## STAFF REPORT

**TO:** City Council  
**FROM:** Ben Prchal, City Planner  
**AGENDA ITEM:** Conditional Use Permit Amendment for Cedar Pet Clinic – 11051 Stillwater Blvd.  
**REVIEWED BY:** Ben Prchal, City Planner

Re: Cedar Pet Clinic: 11051 Stillwater Boulevard  
Engineering Site Plan Review

**To:** Ben Prchal, City of Lake Elmo Planner  
**From:** Lucius Jonett, Wenck Landscape Architect  
**Date:** October 12, 2018  
**Subject:** City of Lake Elmo Landscape Plan Review  
Cedar Pet Clinic Conditional Use Permit Amendment, Review #1

**EXISTING CONDITIONS & REMOVALS PLAN**

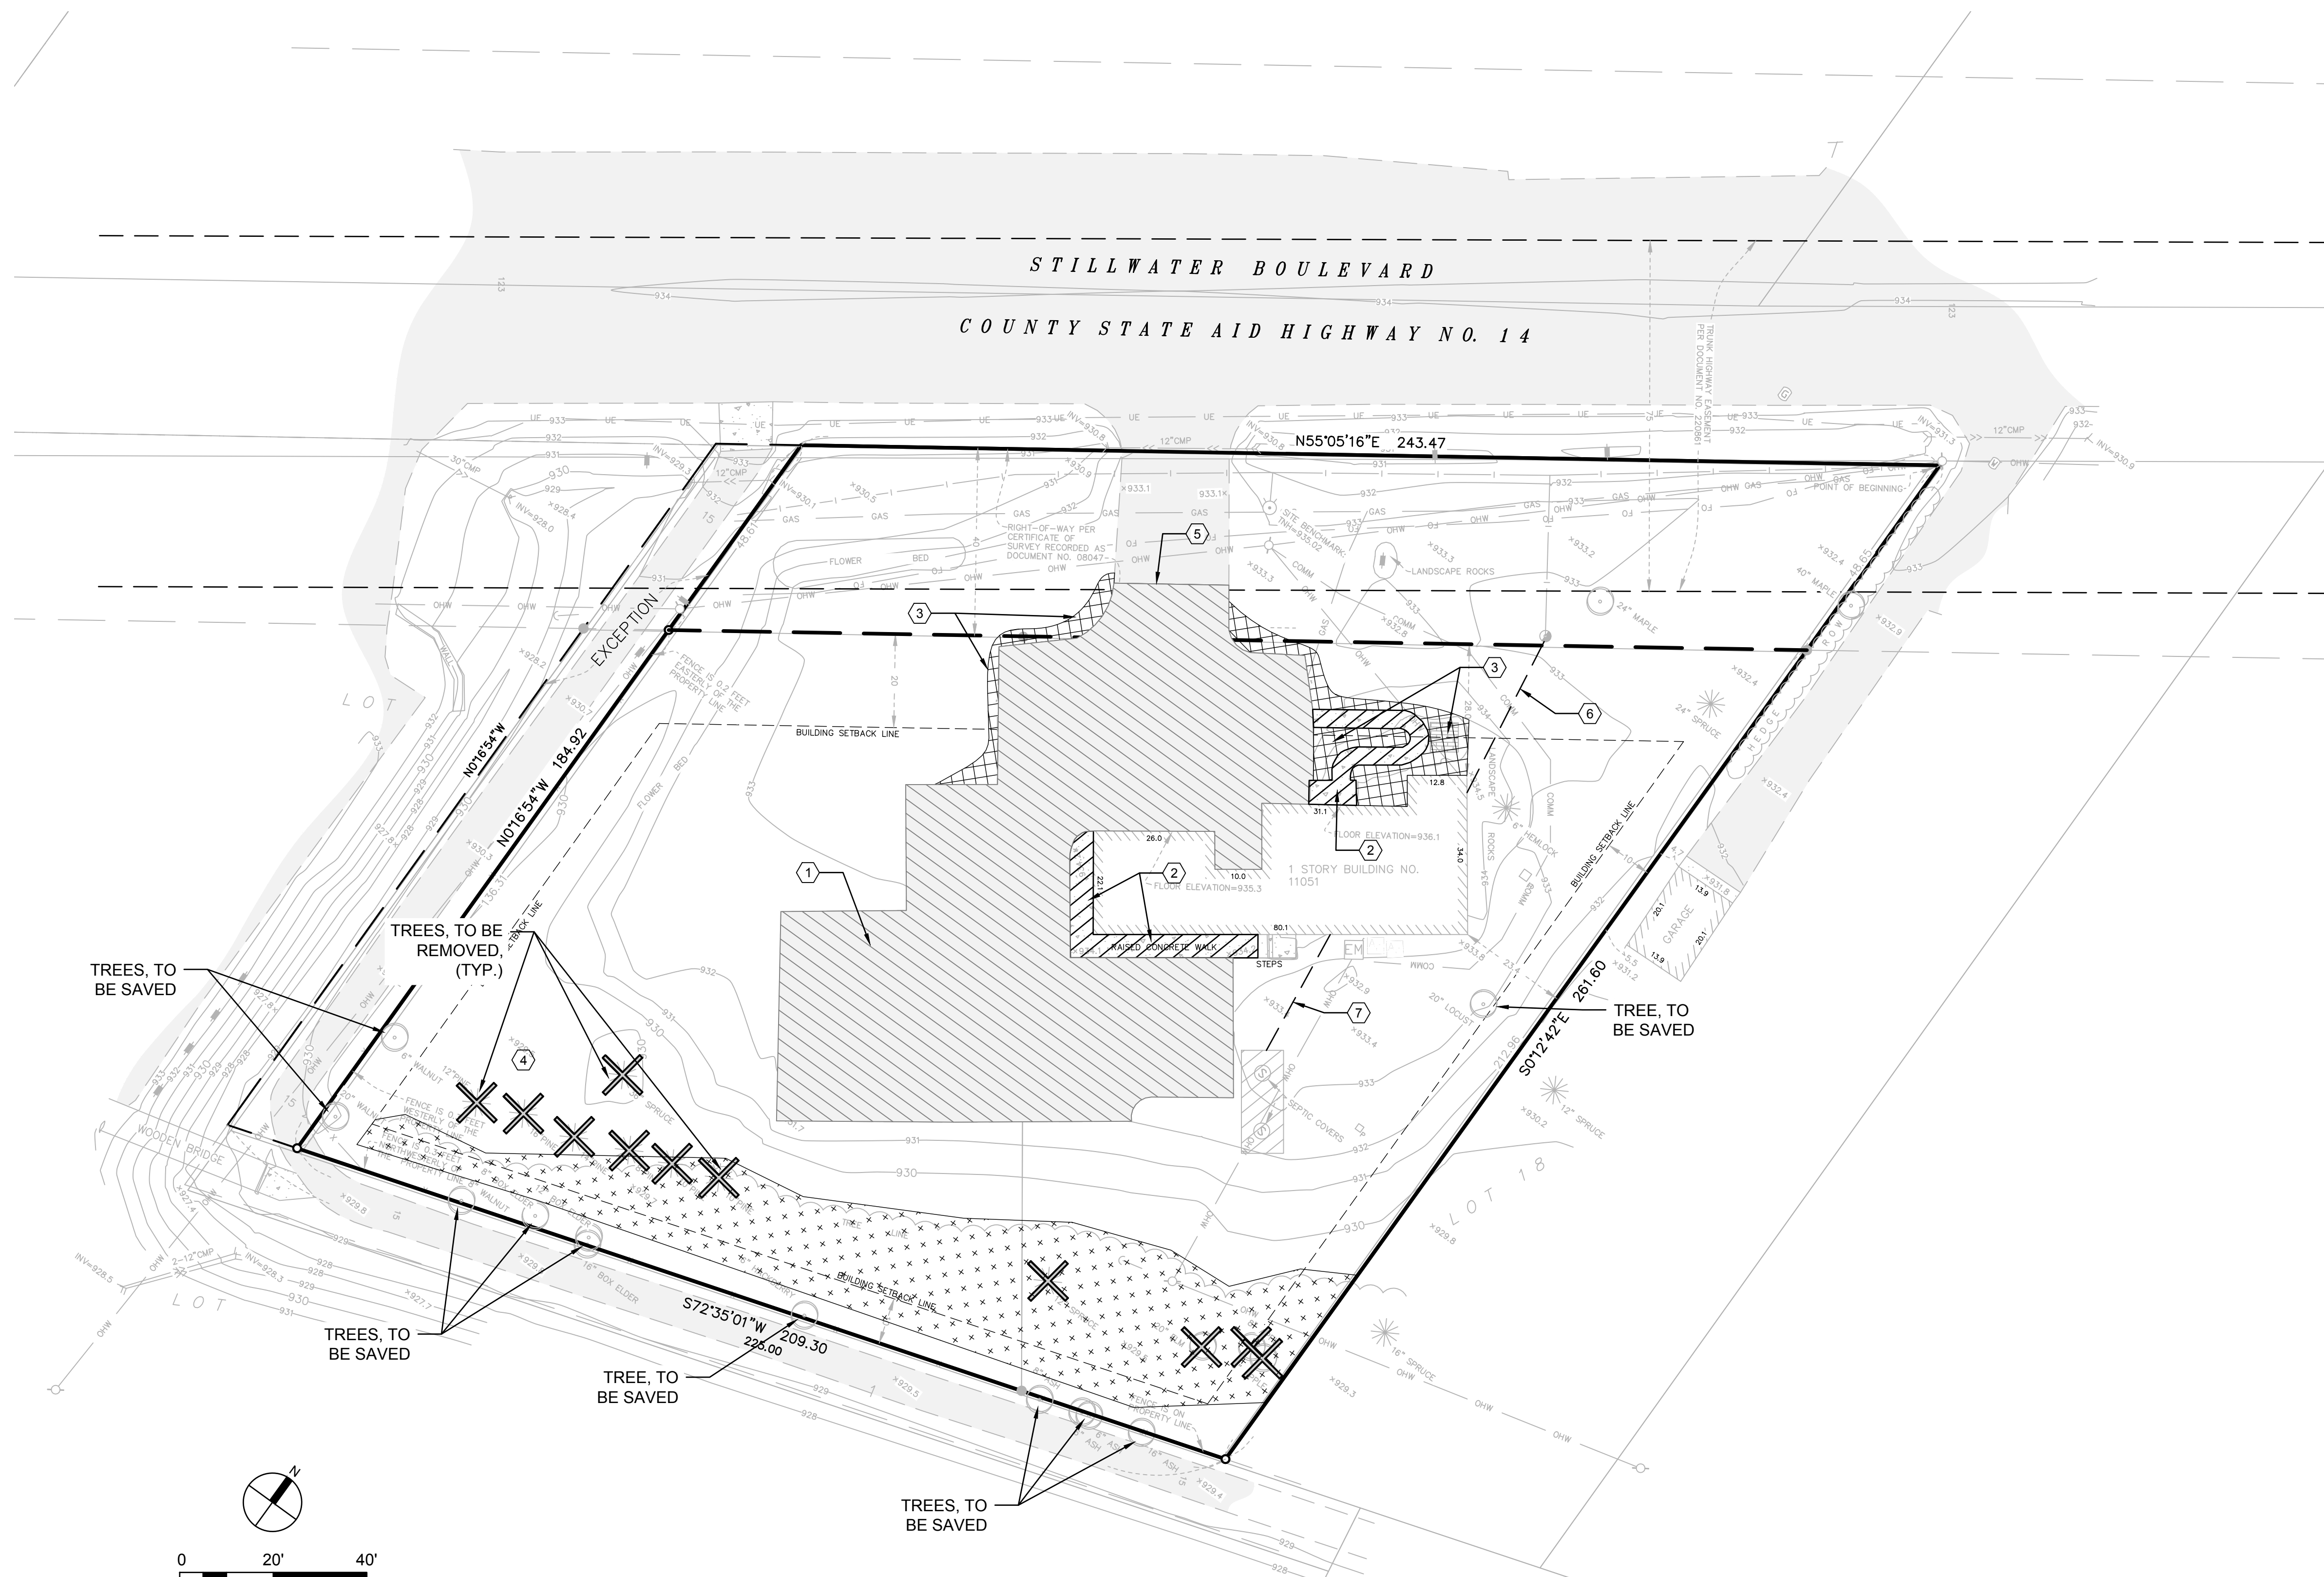
Based on review of the Existing Conditions and Removal Plan, sheet C1, the estimated tree inventory and mitigation calculations are:

2. Tree replacement calculations need to be provided confirming what was deduced from the Existing Conditions and Removals Plan, sheet C1 and to confirm the quantity and type of trees that need to be provided for mitigation of the removals in excess of the 30% removal limit for each category; hardwood, evergreen/deciduous, and common trees.

**GRADING DRAINAGE &  
 EROSION CONTROL PLAN**

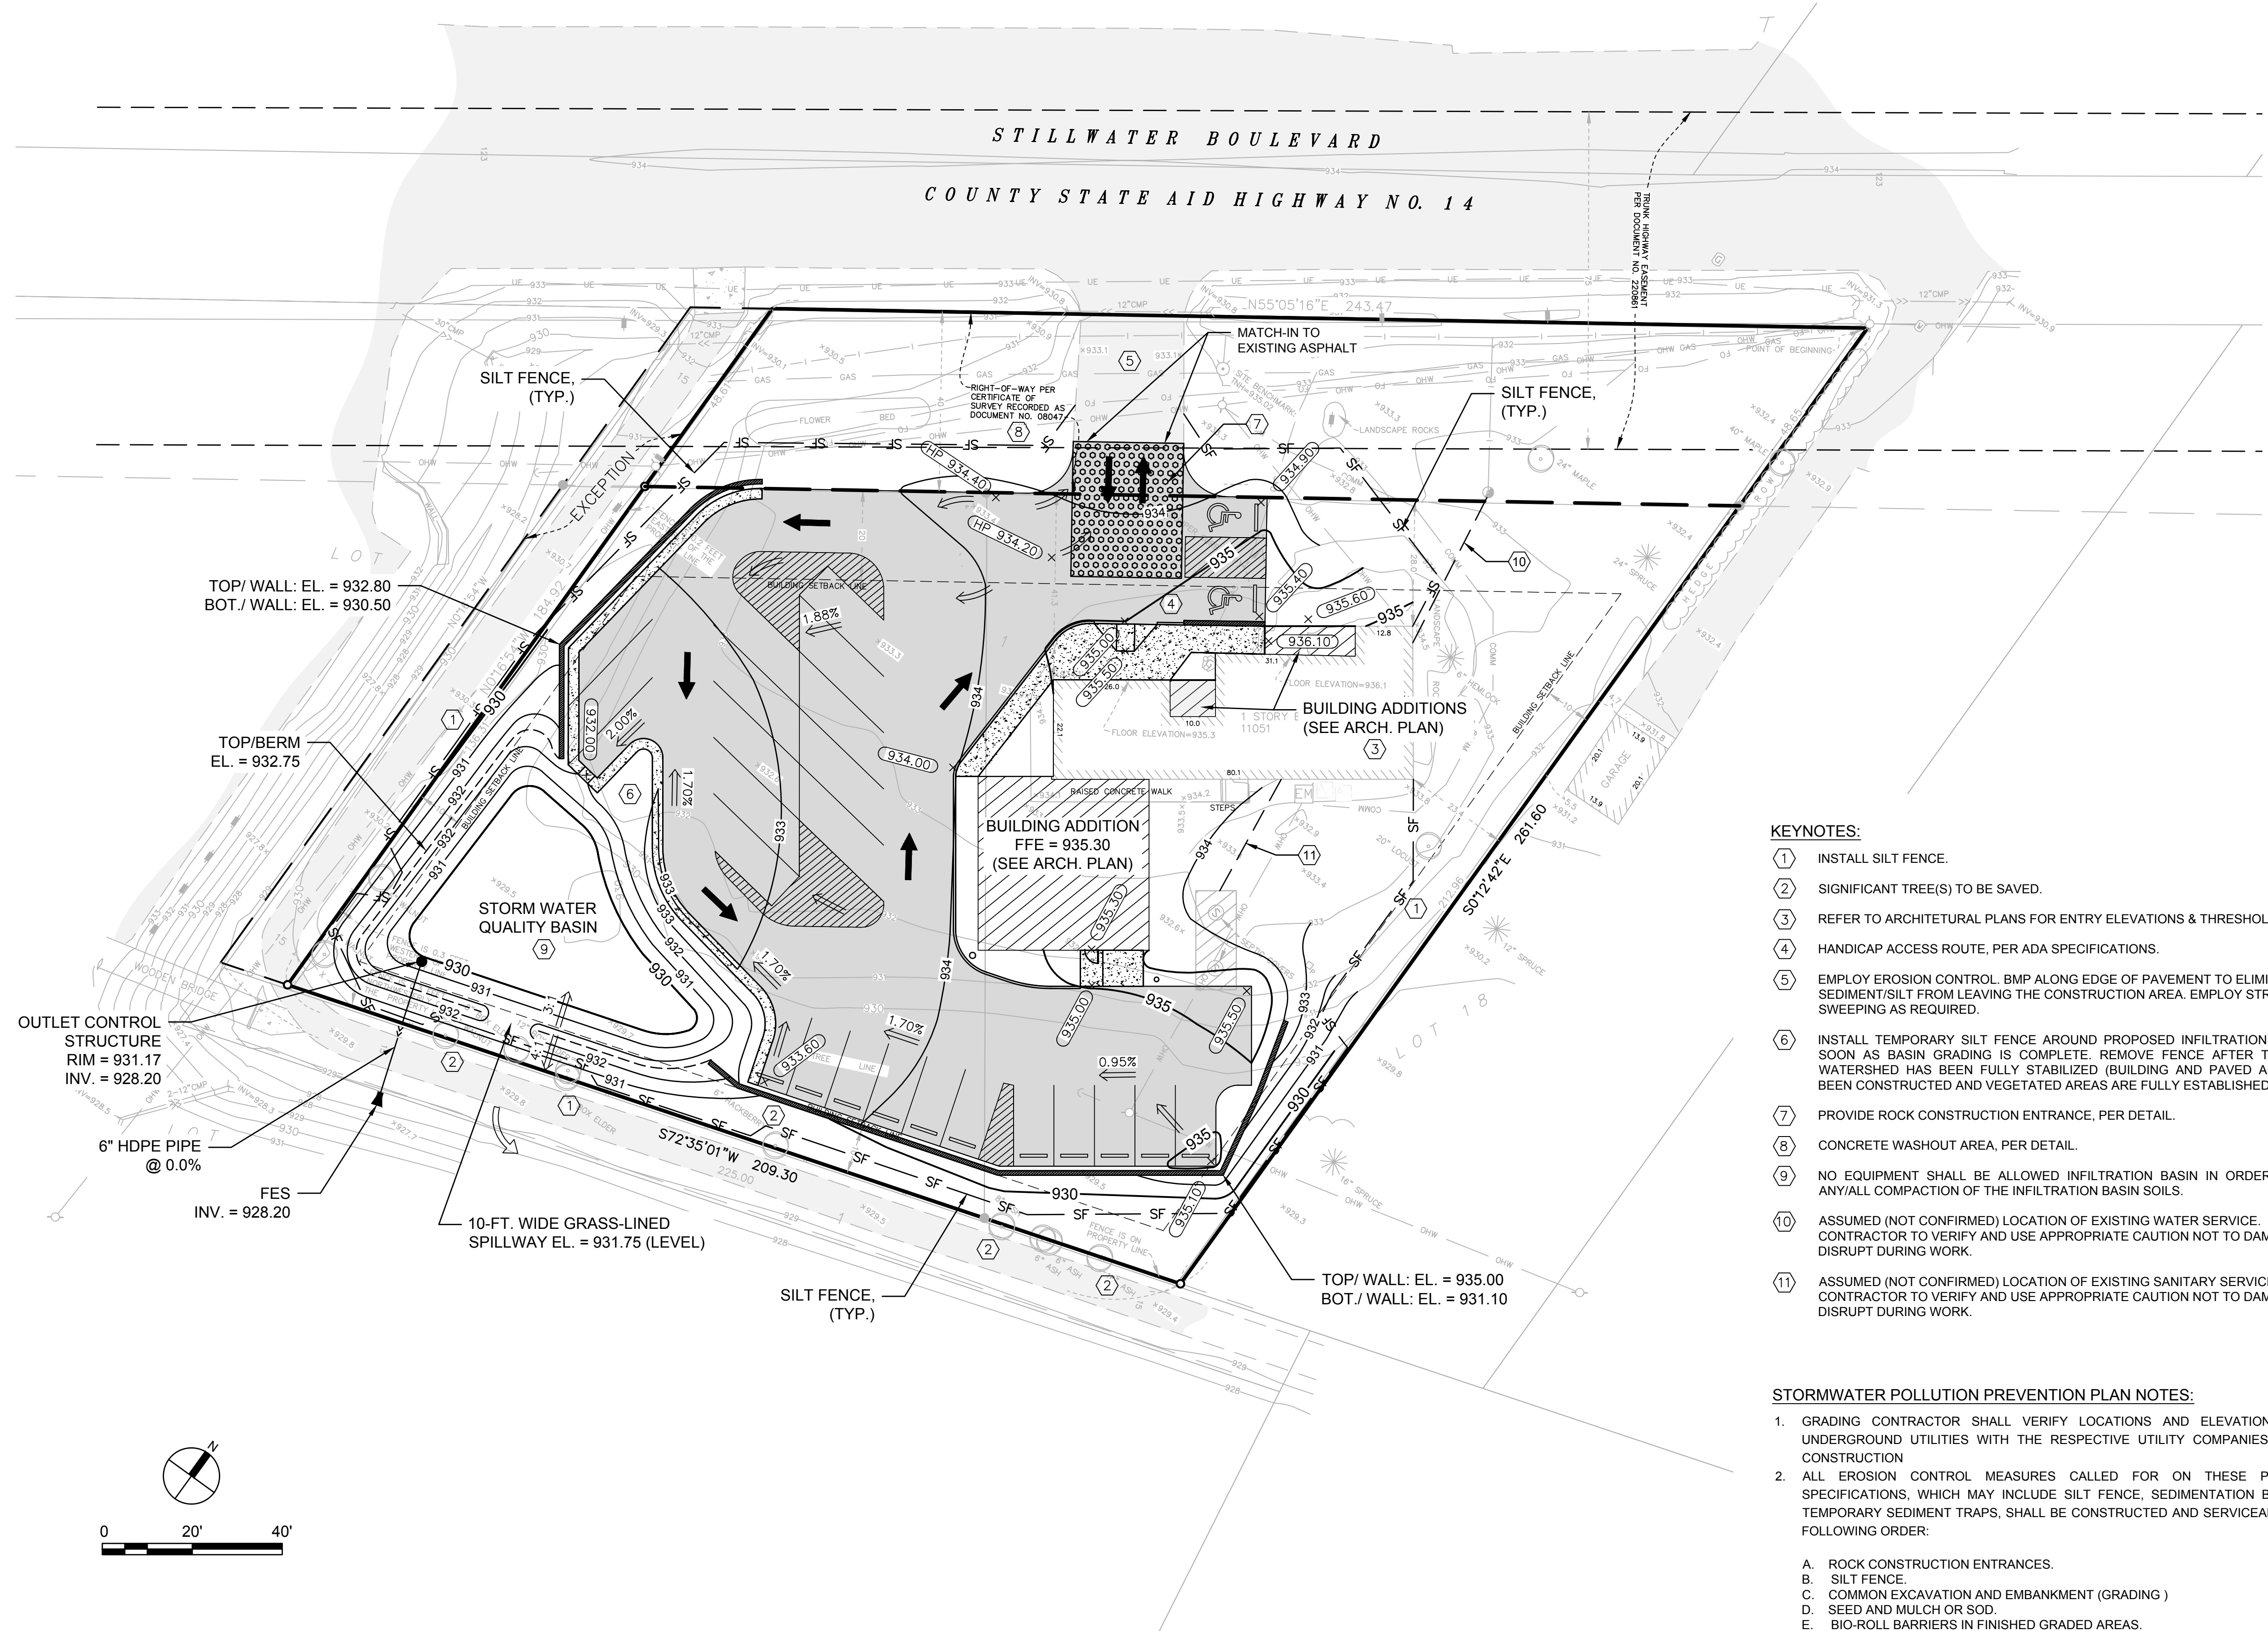
6. A storm water infiltration basin is proposed in the southwest corner of the property to mitigate the new impervious surfaces and to comply with VBWD rules. Soil borings must be taken to verify that the in-place soils are suitable for infiltration. Soils must be type A or B to allow for infiltration practices.
